Well Name: POKER LAKE UNIT 28-21 BS	Well Location: T25S / R31E / SEC 28 / NENE /	County or Parish/State:
Well Number: 127H	Type of Well: CONVENTIONAL GAS WELL	Allottee or Tribe Name:
Lease Number: NMLC062140A	Unit or CA Name: POKER LAKE	Unit or CA Number: NMNM071016X
US Well Number: 3001548955	Well Status: Approved Application for Permit to Drill	Operator: XTO PERMIAN OPERATING LLC

Notice of Intent

Sundry ID: 2635321

Procedure Description: **Spacing, Casing/Cement, Drilling Variance Changes XTO Permian Operating, LLC requests permission to make the following changes to the original APD: No Additional Surface Disturbance Change BHL fr/50'FNL & 750'FEL to 2615'FSL & 1443'FEL, Section 17-T25S-R31E Casing/Cement design per the attached drilling program. Attachments: C102 Drilling Program Directional Plan Multibowl Diagram

30" x 11-3/4" x 7-5/8" x 5-1/2" MBU-3T-SF SOW Wellhead System
With 13-5/8" 10M x 7-1/16" 15M CTH-DBLHPS-SB Tubing Head
And 7-5/8" & 5-1/2" Fluted Mandrel Casing Hangers

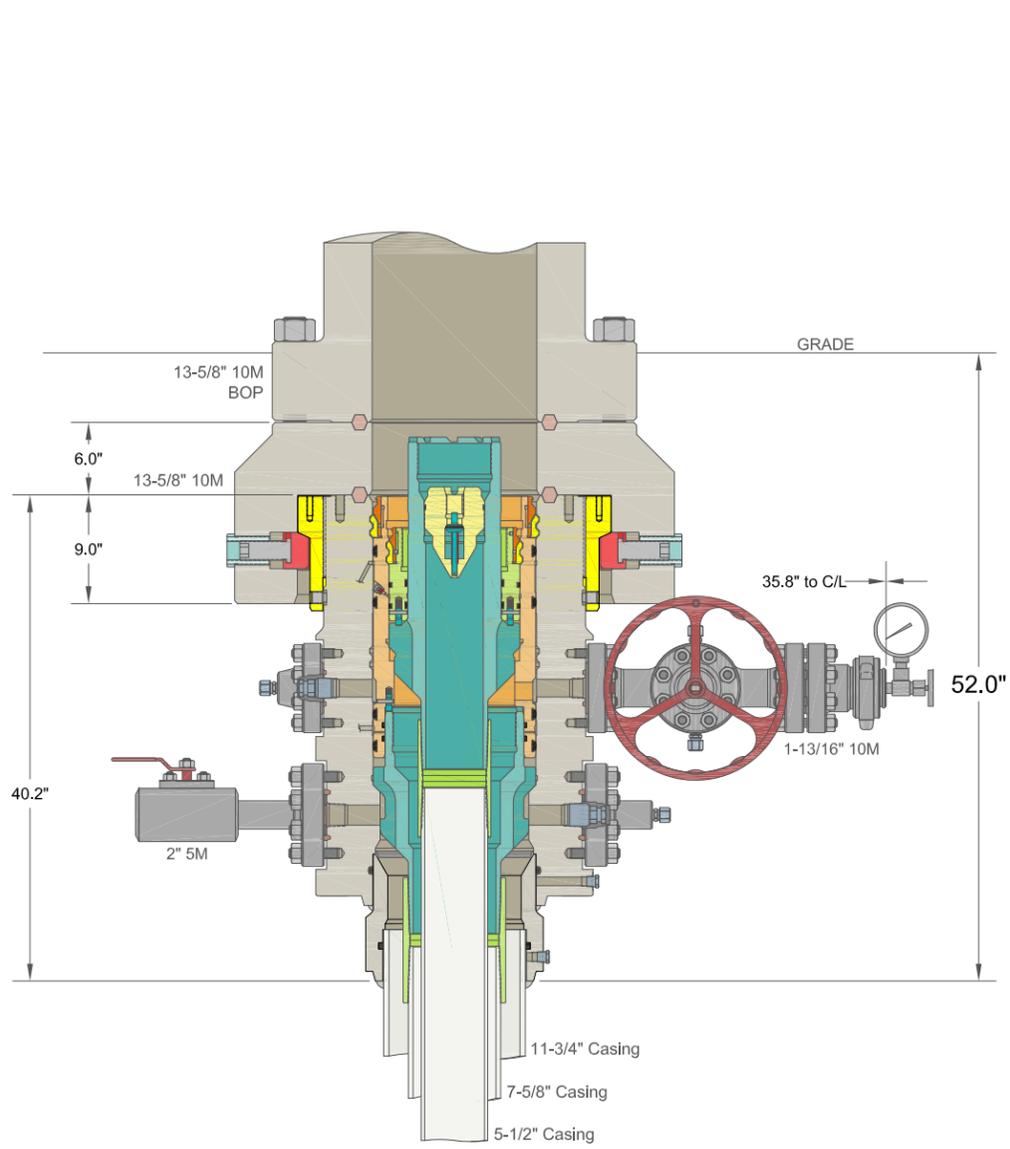
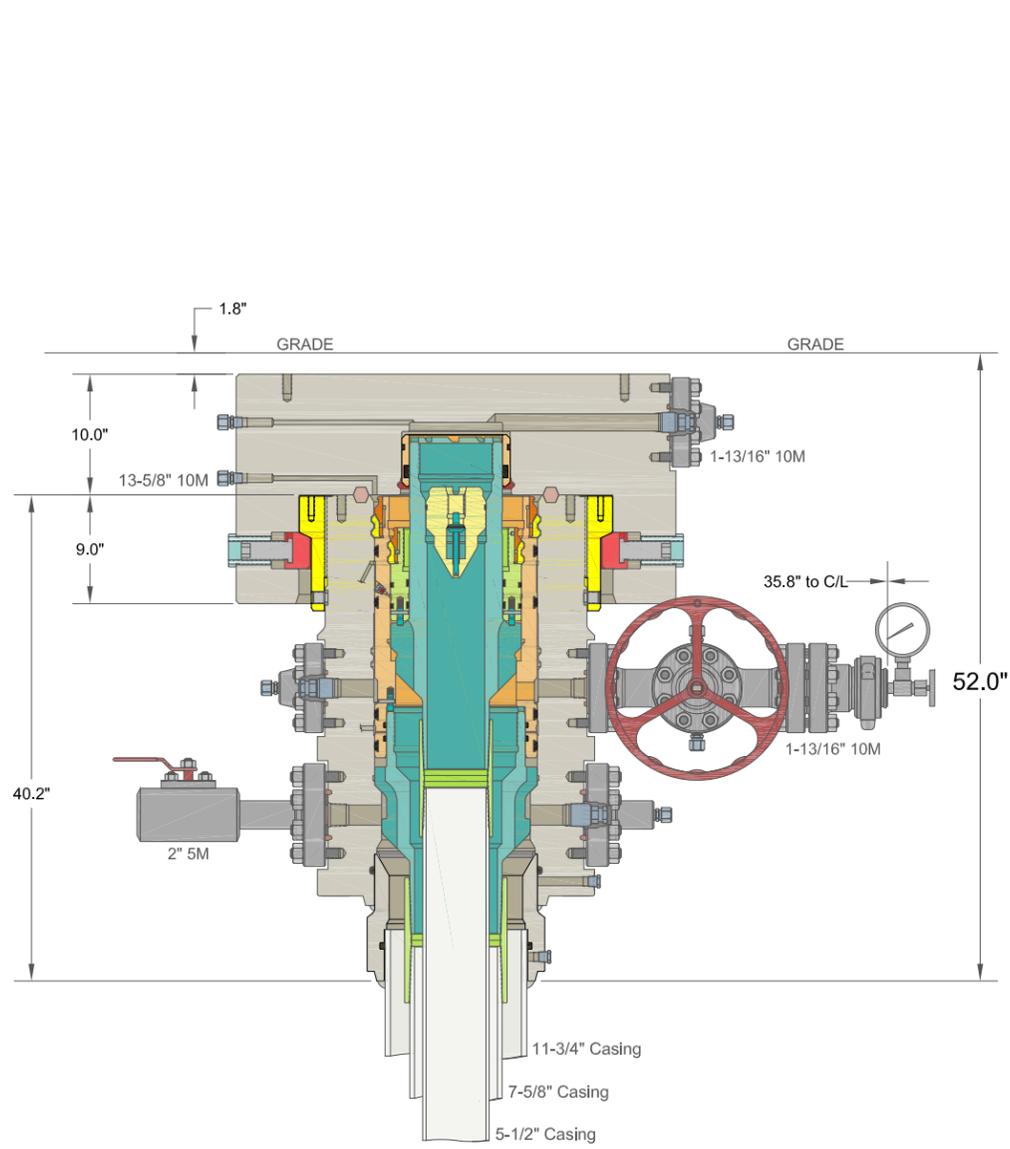
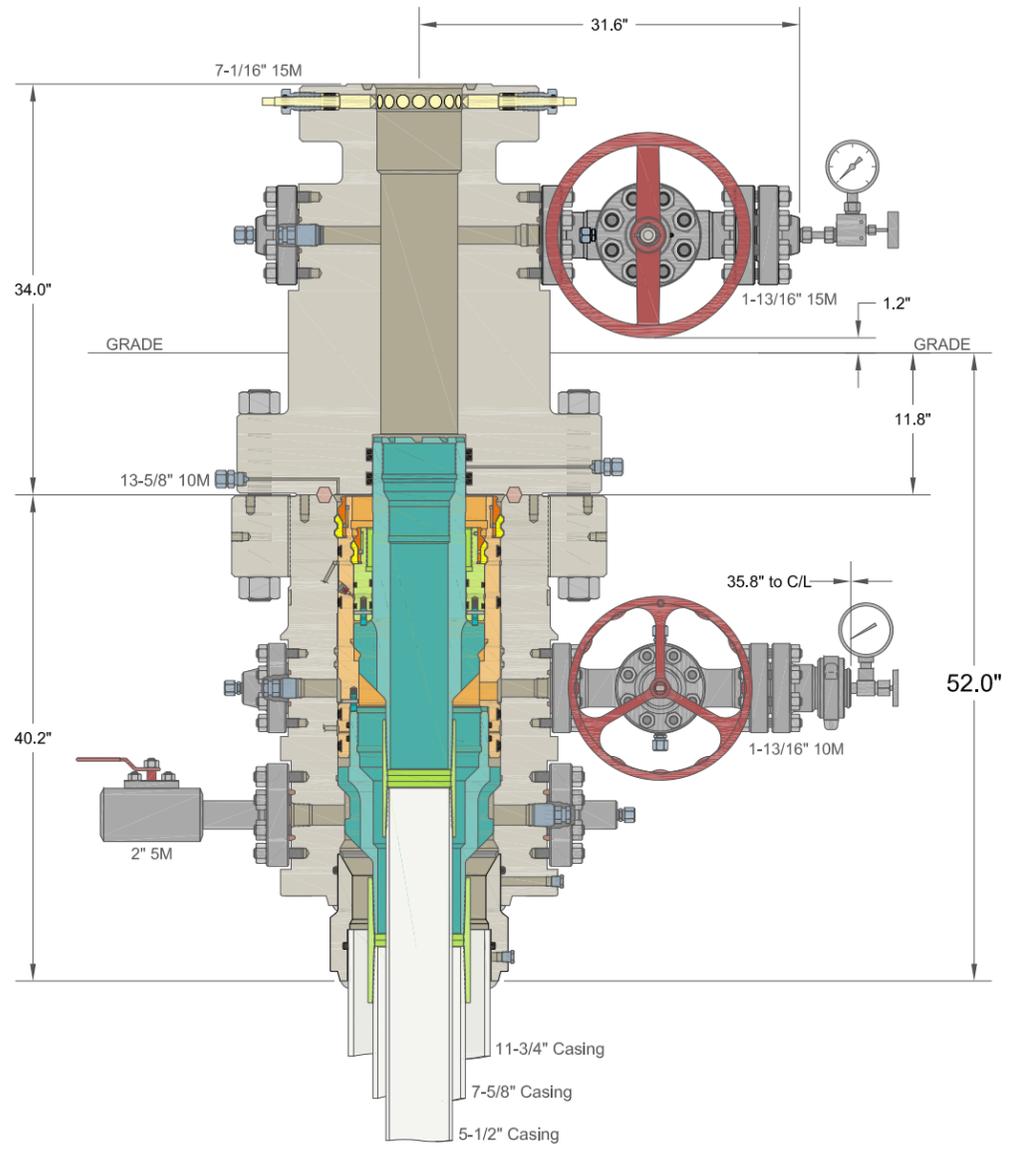
- A. Starting Head: 13-5/8" 10M top flange x 11-3/4" SOW bottom
 B. Tubing Head: 13-5/8" 10M bottom flange x 7-1/16" 15M top flange
 · Wellhead will be installed by manufacturer's representatives.

- Manufacturer will monitor welding process to ensure appropriate temperature of seal.
- Operator will test the 7-5/8" casing per BLM Onshore Order 2
- Wellhead Manufacturer representative will not be present for BOP test plug installation

- a. Wellhead shall be installed by manufacturer's representatives, submit documentation with subsequent sundry.
 - b. If the welding is performed by a third party, the manufacturer's representative shall monitor the temperature to verify that it does not exceed the maximum temperature of the seal.
